AGENDA
Historic Yorktown Design Committee
Regular Meeting
York Hall – East Room - 301 Main Street
April 20, 2005
7:00 PM

Historic Yorktown Design Committee

MEMORANDUM

SUBJECT: Application No. HYDC-8-05: Duke of York Motor Hotel

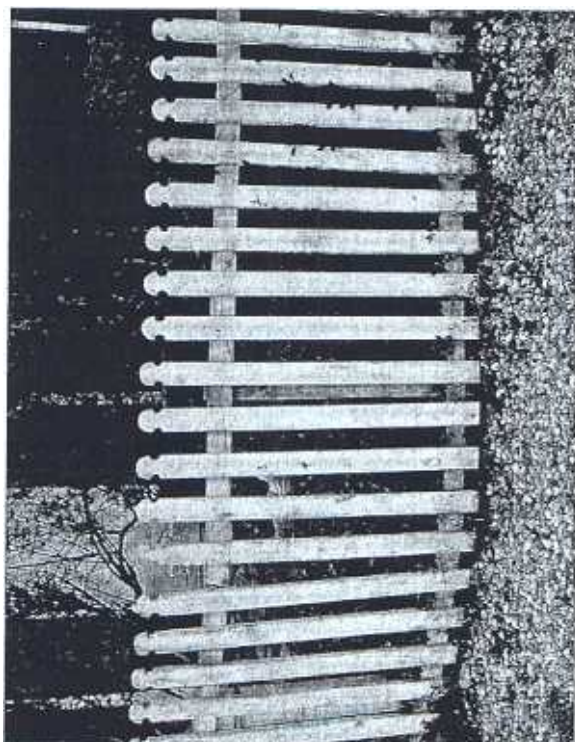
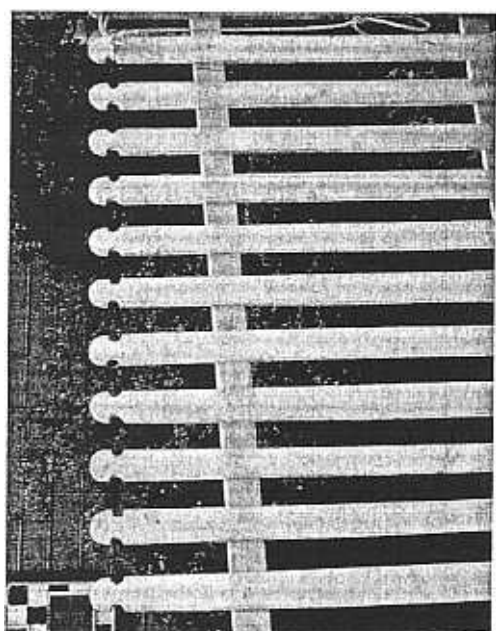
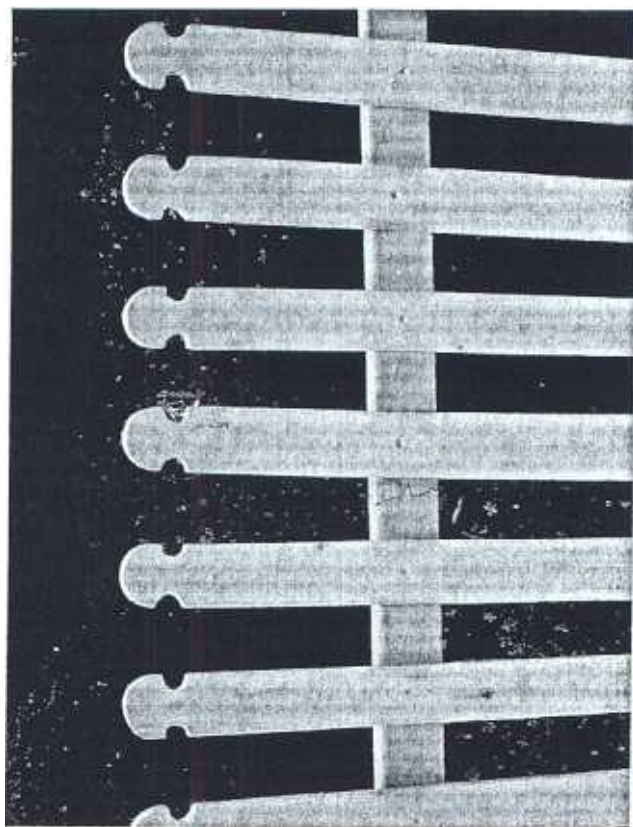
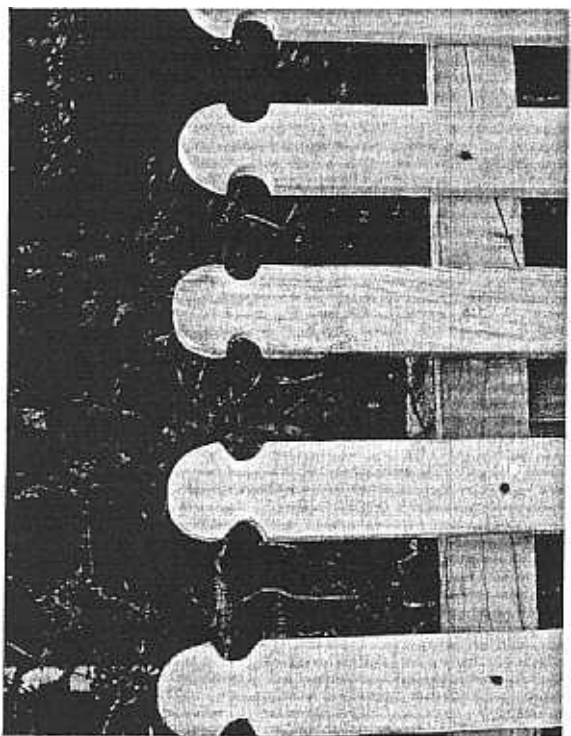
Existing split-rail fence to be replaced with white picket fence

New fence to be the same white picket design as existing in background

Staff believes that the proposed fence replacement will be visually appealing and compatible with its surroundings. Removal of the existing split rail fence and its replacement with a white picket fence matching the style already located on the Church street side of the property is entirely consistent with the Guidelines, in staff's opinion. Therefore, it is recommended that the Committee find the proposal consistent with the Guidelines and that the application be approved.

Windmill Point 1711 townhouses

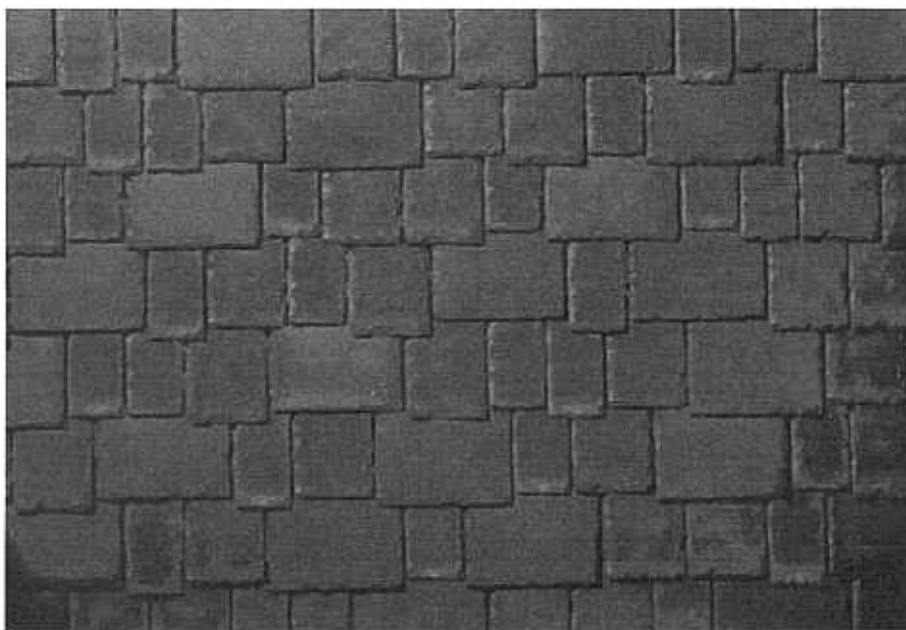
In this application, the Windmill Point 1711 Owners Association, Inc. is requesting approval to replace the existing wood-shake shingles roof on the Windmill Point 1711 townhouses with a composite slate roof (Lambrite by Tamko, or equivalent) in a slate gray color. The terms of the Yorktown Design Guidelines require that the Historic Yorktown Design Committee (HYDC) approve the use of a different roofing material. The subject property is located at 206-212 Ambler Street.

Staff believes that the proposed roof replacement will be visually appealing and compatible with its surroundings. The townhouse units are designed to resemble a large single-family home with dependency wings and because of the mass of the structure staff believes that the slate-like roofing material is appropriate. The applicant has submitted two shingle samples – a light and dark gray – and staff believes that either shade would be appropriate. Therefore, it is recommended that the Committee find the proposal consistent with the Guidelines and that the application be approved.
